Solicitation Addendum

Addendum No.: 1
Solicitation No.: 20-R074345SAM
Solicitation Title: Lena Road Landfill Stormwater System Revisions
Addendum Date: June 10, 2020
Procurement Contact: Sherri Meier

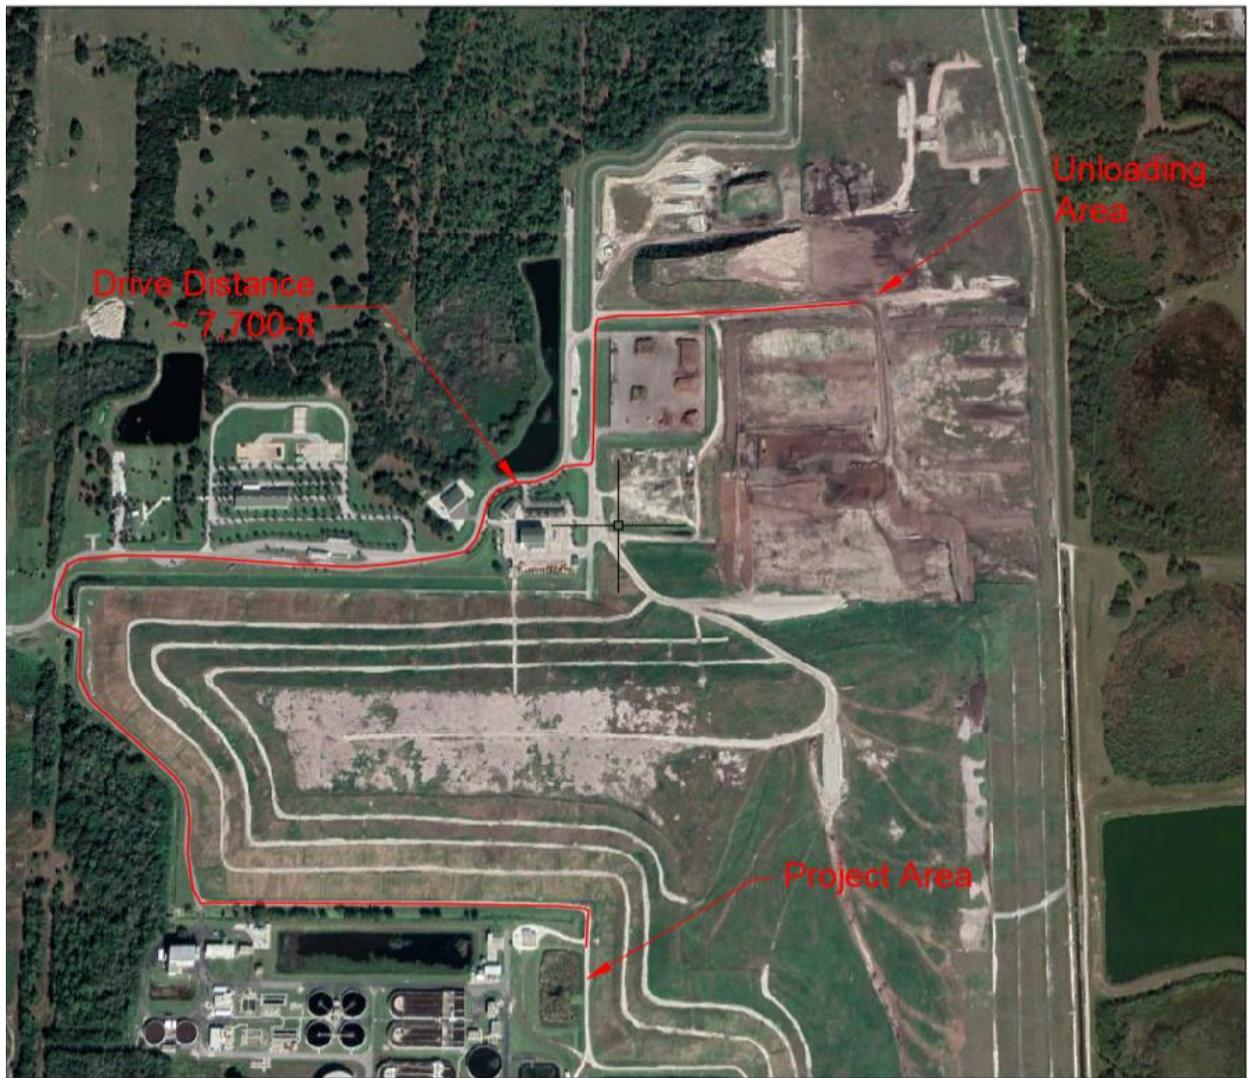
Q9. Confirm if slipline on sheet #5 is pre-existing.

R9. Yes. The concrete pipe was previously slip-lined and no work on this culvert is included with this project. Please note that Drawings 5 and 8 are intended to identify existing site conditions while Drawings 6 and 7 define the work. Finally, drawing 6 has been updated and attached to clarify the culvert location from which an existing grout plug must be removed.
